Addendum 02
SFISD RJ Wollam Elementary School
& Santa Fe Junior High School
Generator Installation

18 April 2022

This addendum modifies the original Proposal Documents dated March 25, 2022 and forms a part of the Contract Documents. Acknowledge receipt of this Addendum in the space provided on the Proposal Form. Failure to do so may subject Proposer to disqualification.

JH-E5.1

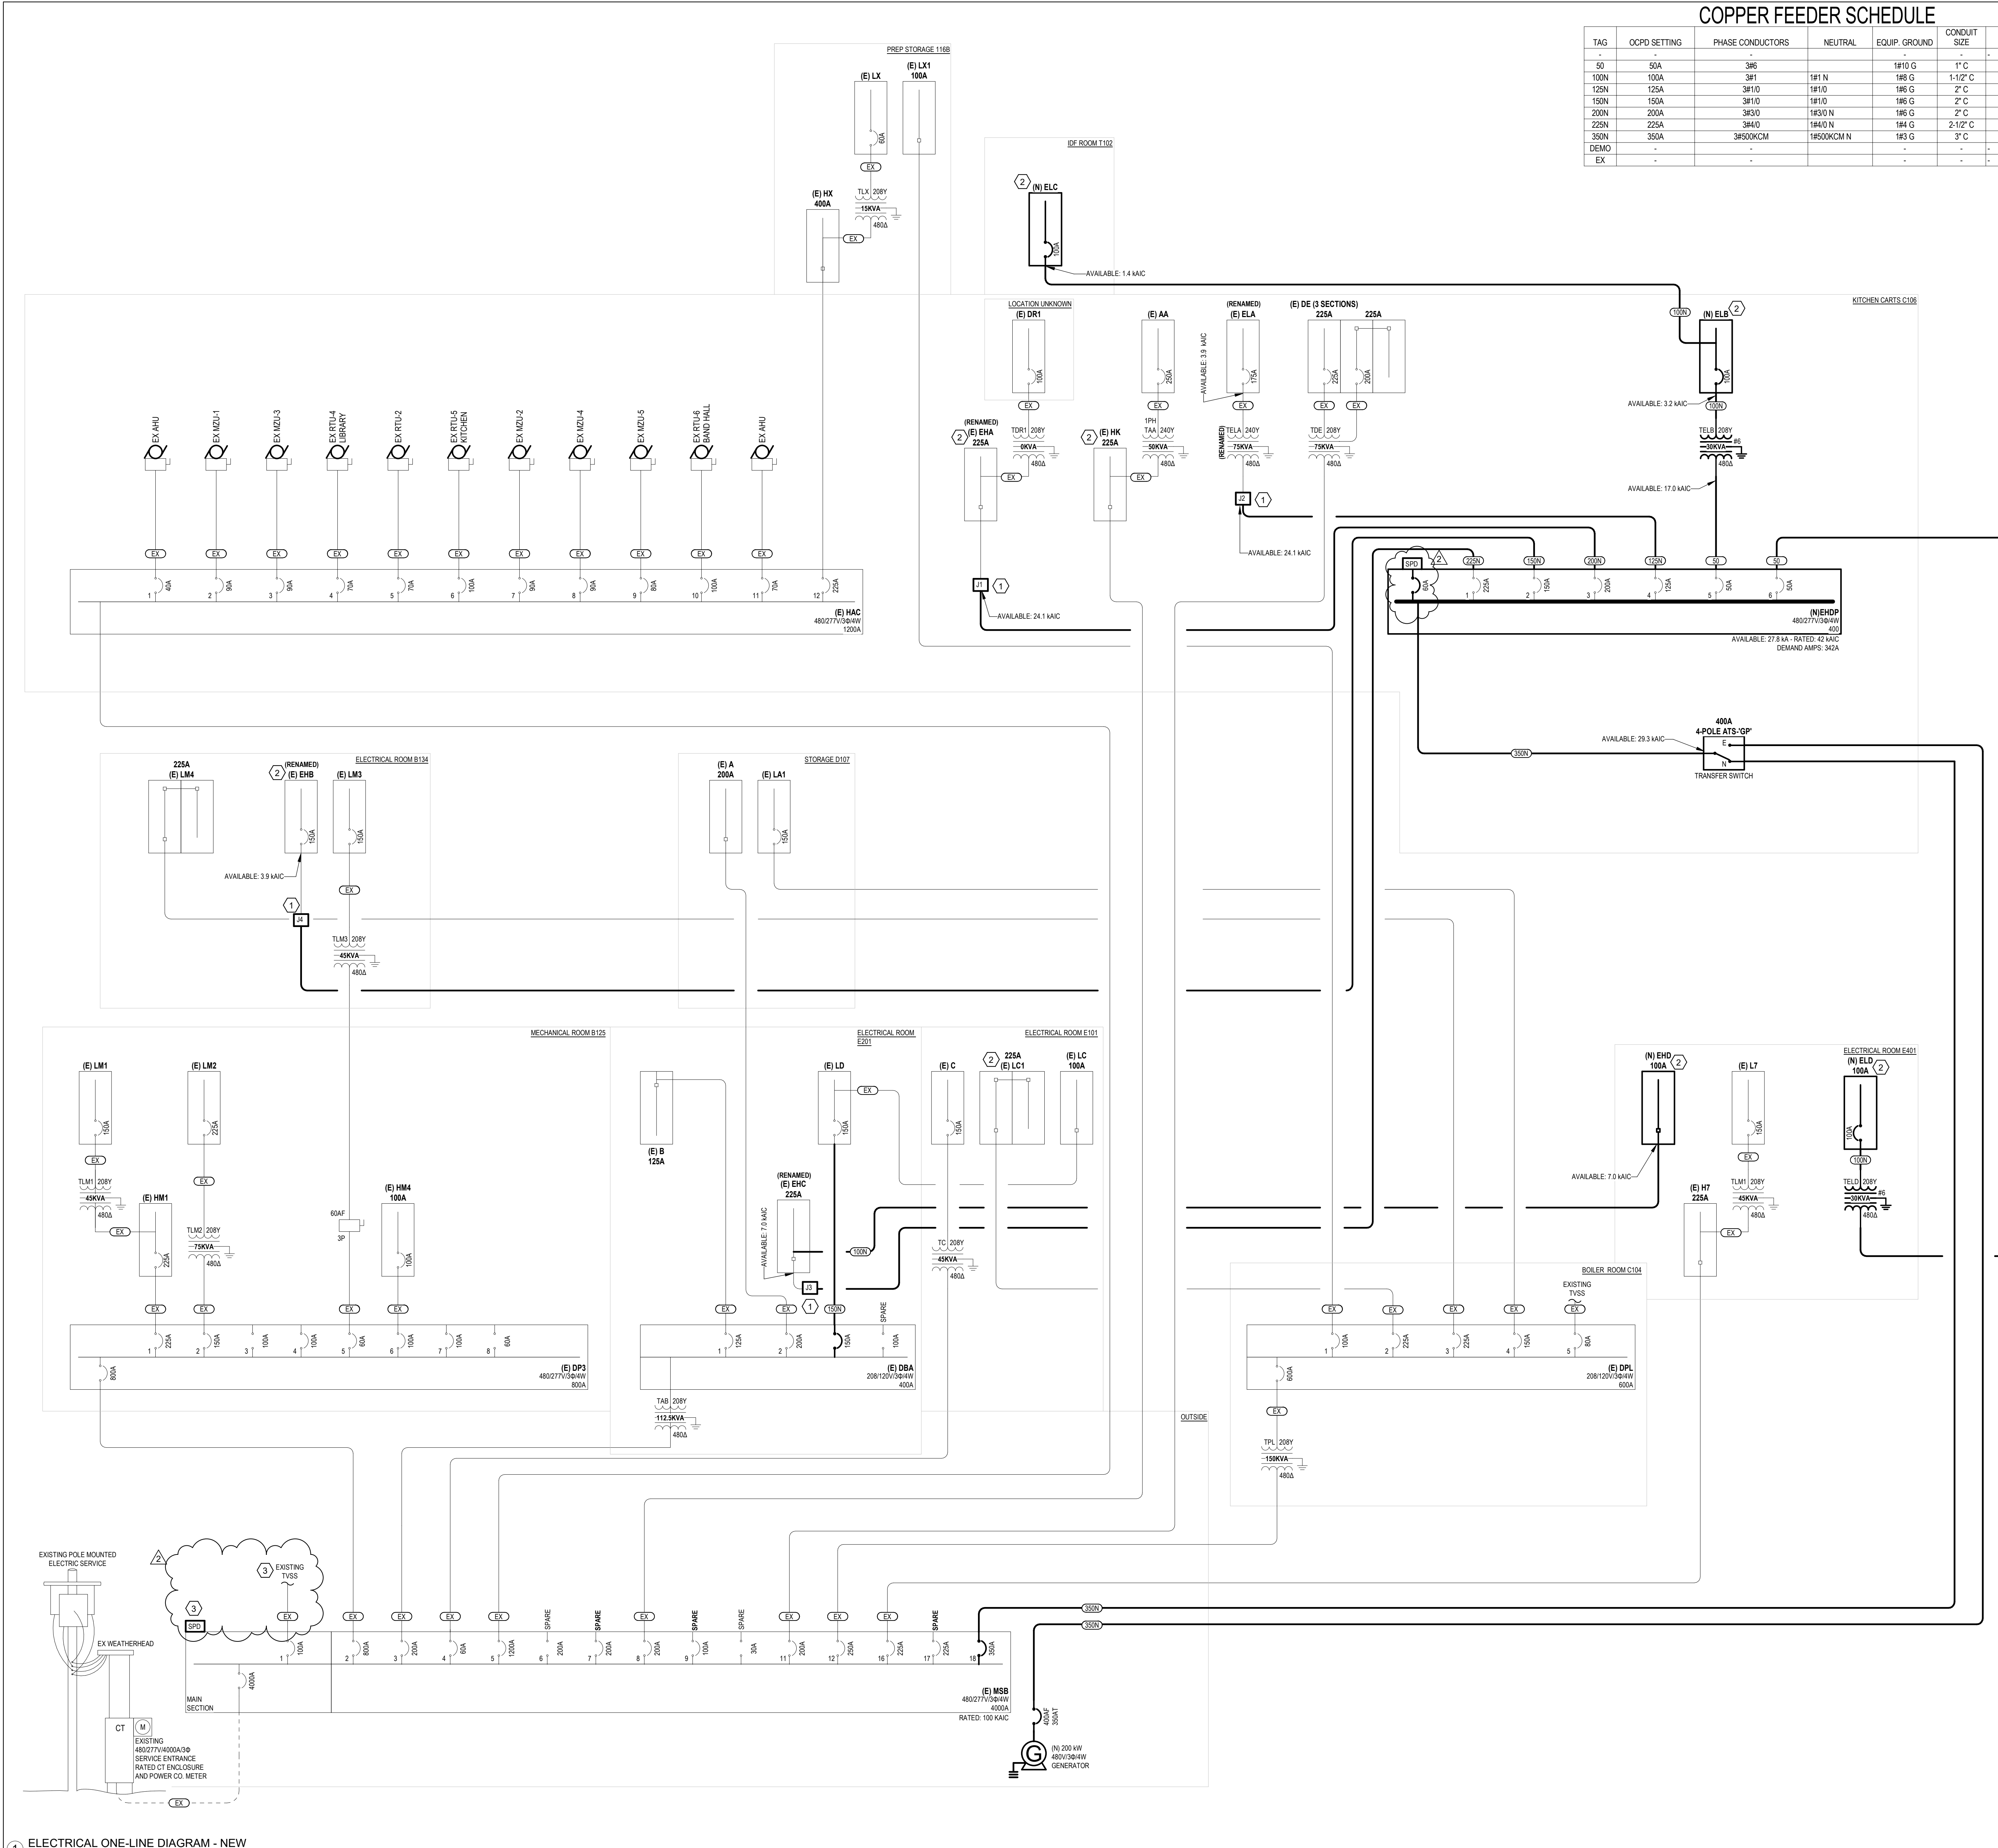
- 06 JH-E5.1 – ELECTRICAL ONE-LINE DIAGRAM – NEW SCOPE:
 - a. Replace existing service entrance TVSS with new service entrance rated SPD at main service switchboard as an add alternate.

- b. Add new SPD to new distribution panel 'EHDP'.

- NEW JUNCTION BOX INSTALLED ON WALL OF ELECTRICAL ROOM (SEE SHEET JH-E5.0). EXTEND CONDUIT AND FEEDER FROM JUNCTION BOX OVERHEAD TO NEW EMERGENCY DISTRIBUTION PANEL "EHD" AS INDICATED.
- LAND RELOCATED CIRCUITS TO THIS PANEL FROM EXISTING PANEL AS INDICATED ON THE PANEL SCHEDULES.
- AS AN ADD-ALTERNATE, REPLACE EXISTING TVSS WITH NEW SERVICE ENTRANCE RATED SPD PER SPECIFICATIONS.
